# LANDSCAPE & TREES

# LANDSCAPE & TREES

# Incompetent Landscape Impact Assessment

## “Mitigation Measures” that make impacts worse!

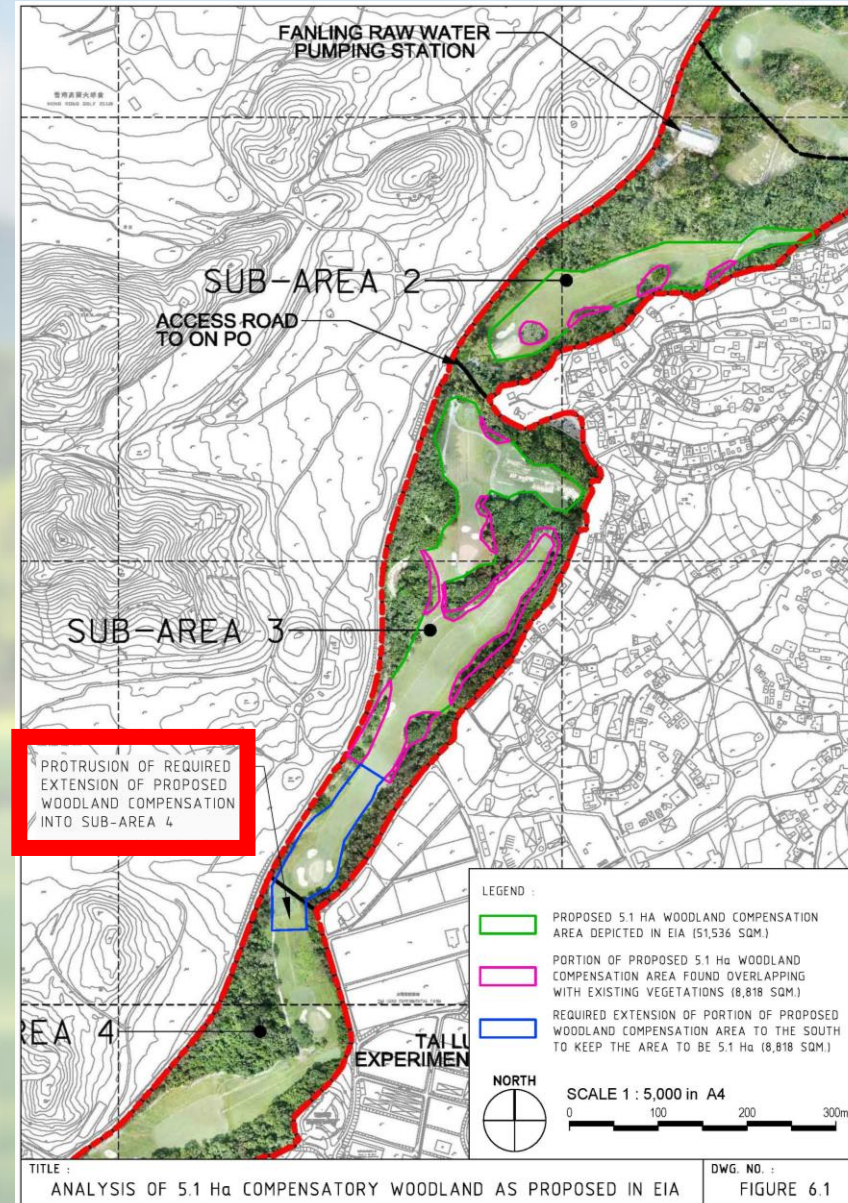
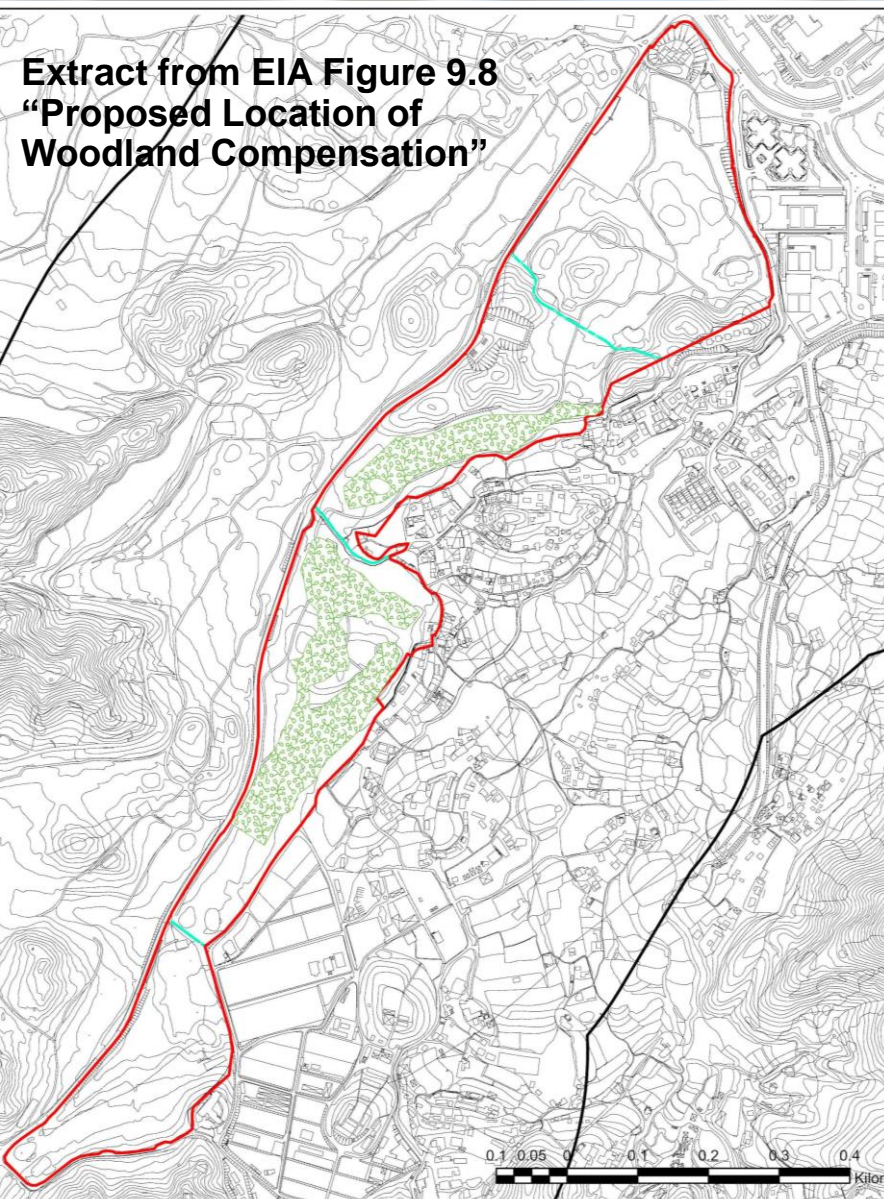
- The proposed 5.1ha Woodland Compensation shown in EIA Figure 9.8 (on far left) is wrongly plotted and overlaps with existing woodland areas.
- When correctly plotted (plan on near left) to avoid the existing woodland, 5.1ha of Woodland Compensation would extend into Sub-Area 4, thus threatening the ground hydrology at the site of the critically endangered Chinese Swamp Cypress.
- **The assessment cannot be trusted.**

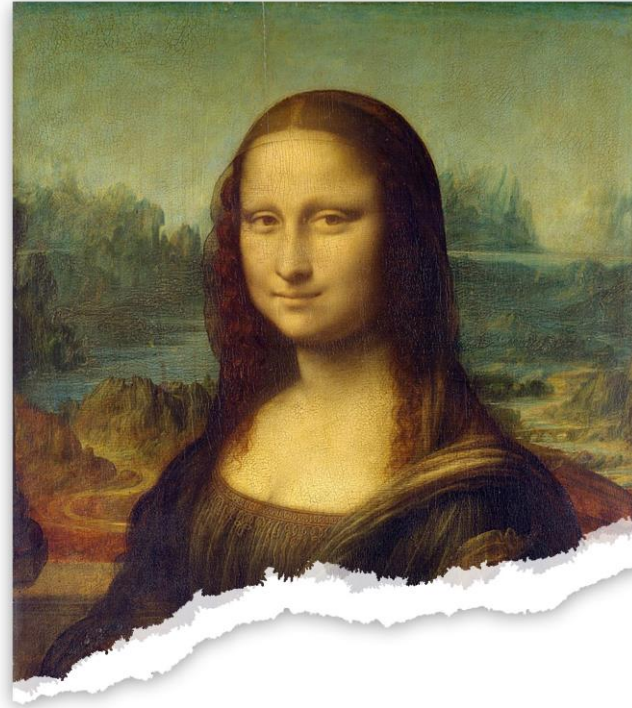
- EIA considers this impact “Acceptable”!

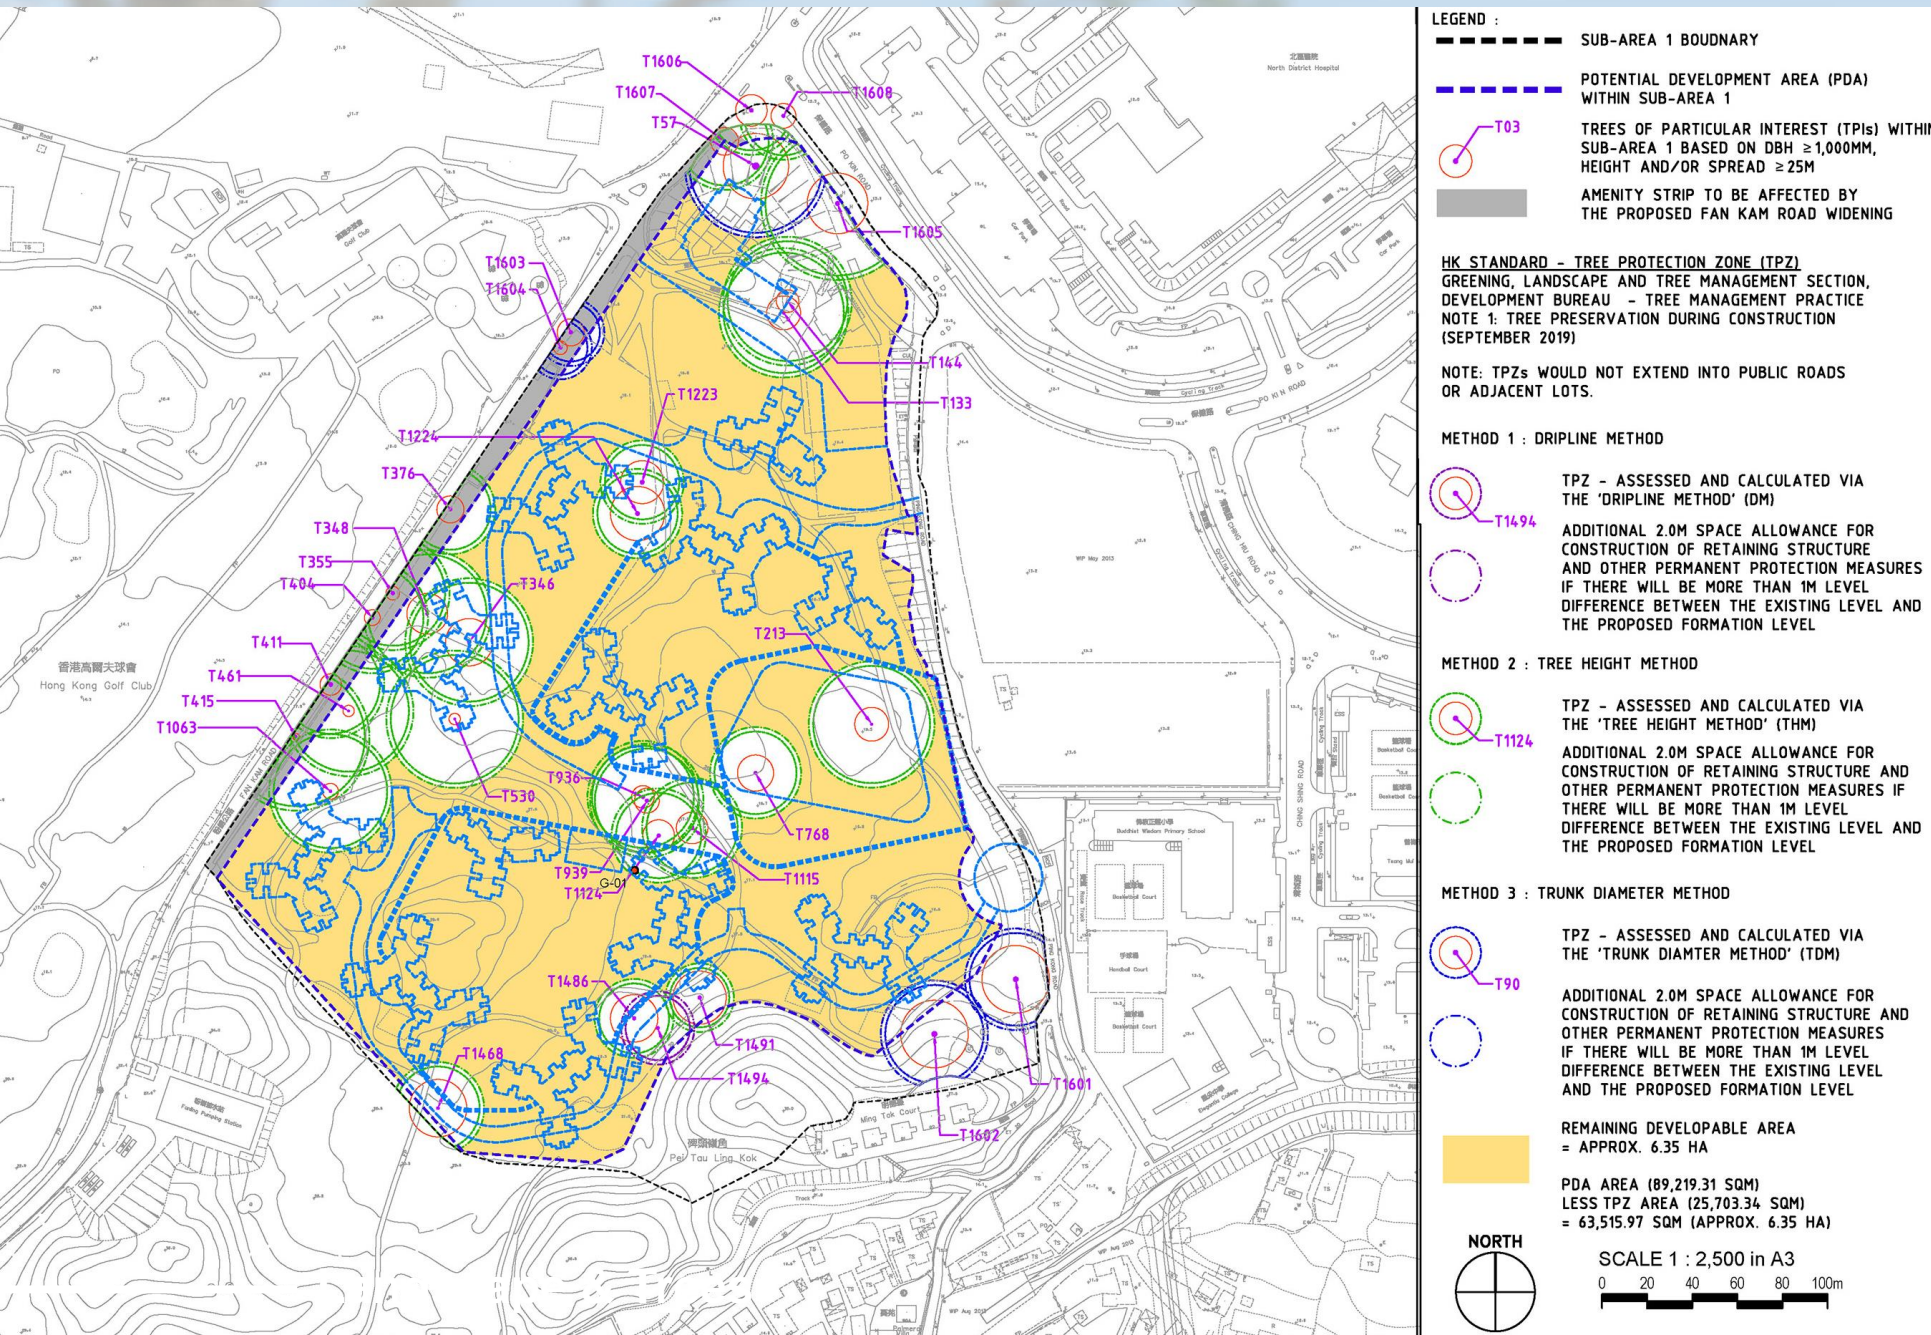
- This Plan shows the Tree Protection Zones (TPZs) required around each pOVT to preserve them during construction.
- TPZs are calculated in accordance with the DEVB's Greening, Landscape and Tree Management Section (GLTMS) Guidelines as appropriate to size and shape of each large pOVT
- Remaining developable area outside the TPZs (shaded yellow) is only 6.35ha and a very impractical shape to develop

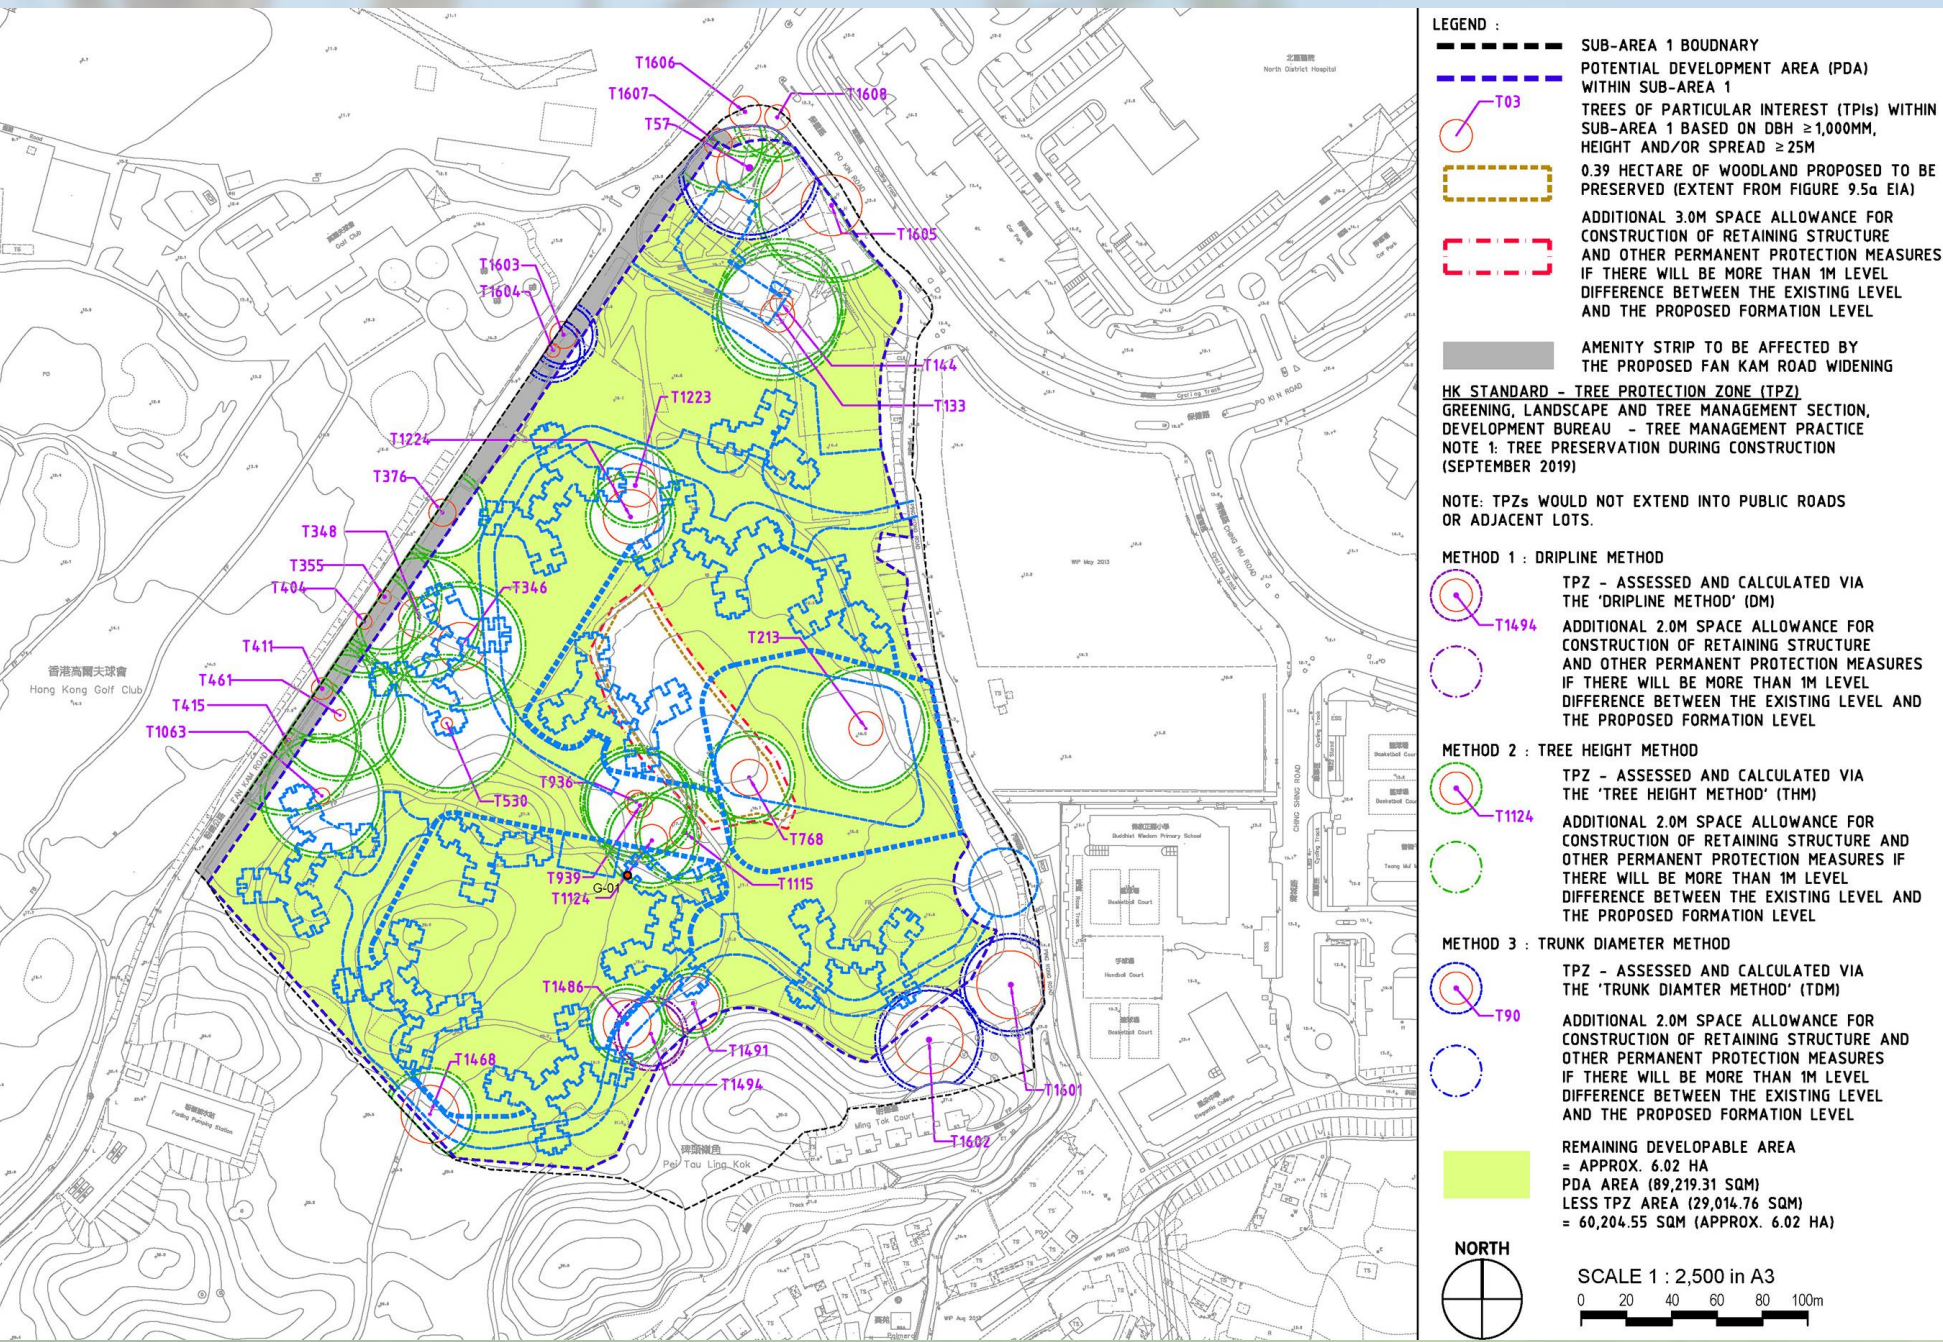
- EIA Approval Conditions stipulate retention of a 0.39ha Woodland in the centre of the site
- Continuing the oversight in the EIA, the EIA Approval Conditions fail to mention the presence of the pOVTs
- Combining retention of the 33 pOVTs with protection of the 0.39ha preserved Woodland further reduces the remaining developable area to only 6.05ha and an even more impractical shape to develop

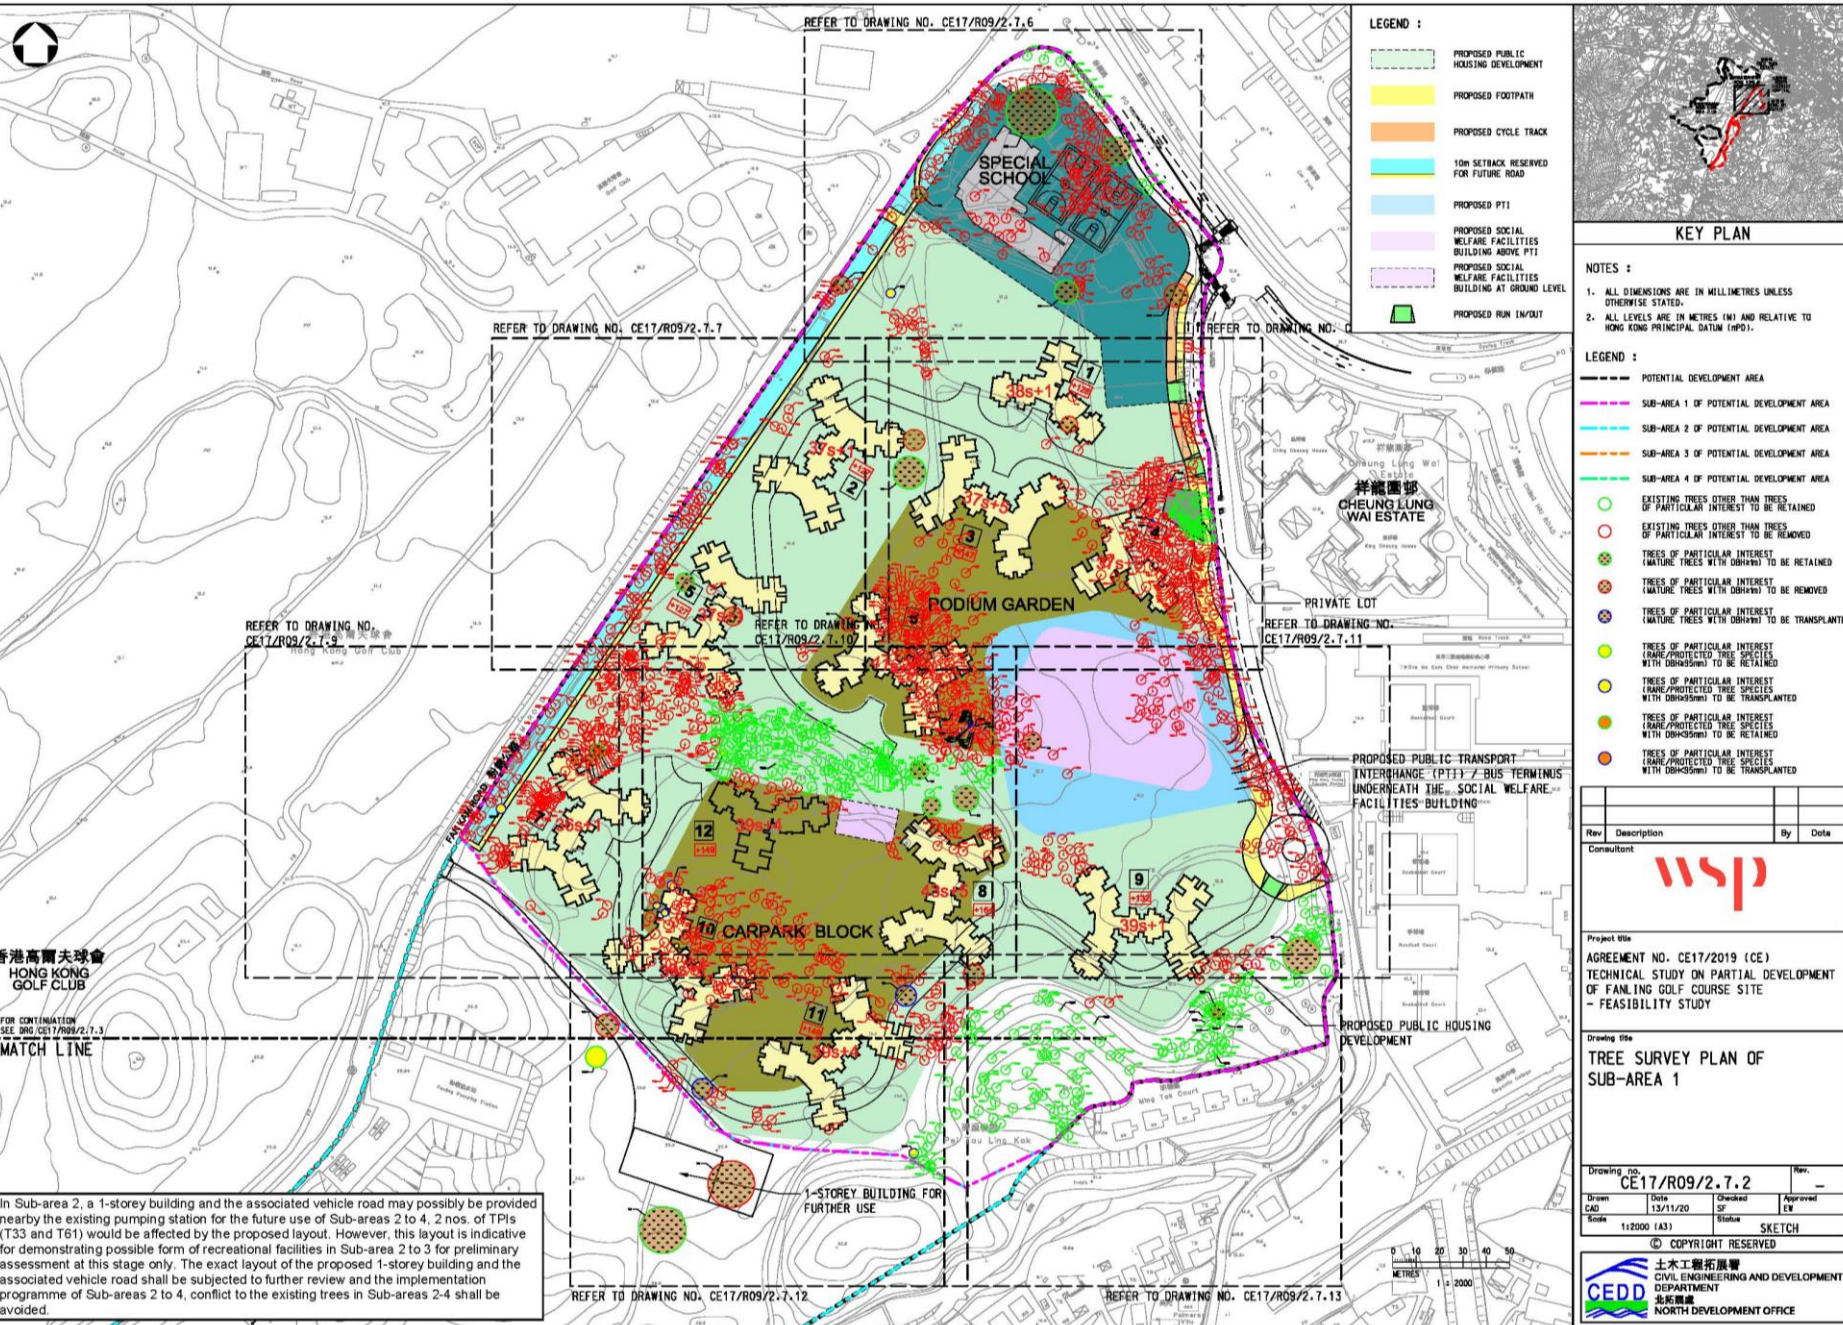
- This EIA Plan shows trees to be retained (green) and felled (red). (Remember – 460 trees missing from this EIA survey plan!)
- EIA proposes to retain only 11 of the 24 large TP1s (should be 33 large TP1s!) and also a tree cluster with ~100 trees on a small knoll between blocks 5, 6 & 12.
- There is no supporting evidence whatsoever to explain the practicality of proposed tree retention.
